Material change for the actuator from PPA+PTFE GF V0 to PA9T GF V0

Type of notification: ☒ PCN ☐ PDN ☒ Short-term action

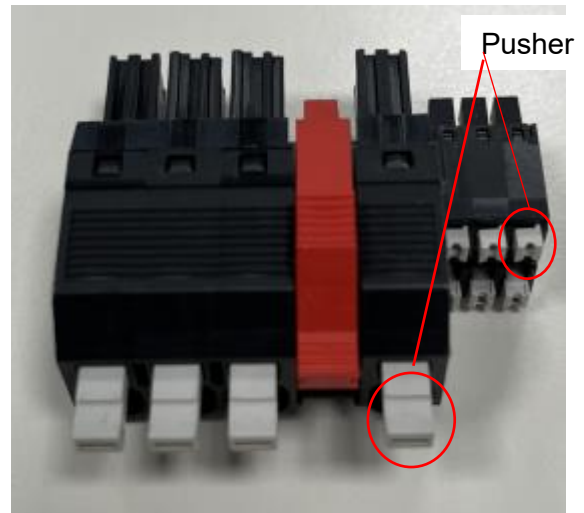
The material change results in a slight change in the color of the pusher. This has no impact on the specified product properties.

sample: old version

Sample: new version

Due to a long-term supply shortage of **PPA+PTFE GF V0** - the material previously used for the actuator (pusher) - we are switching to **PA9T GF V0**.

Equivalence in terms of the relevant technical properties has been verified. Additionally, the new material is PFAS-free and thus represents a more environmentally friendly alternative. Both materials have **UL 94 V-0 certification**.
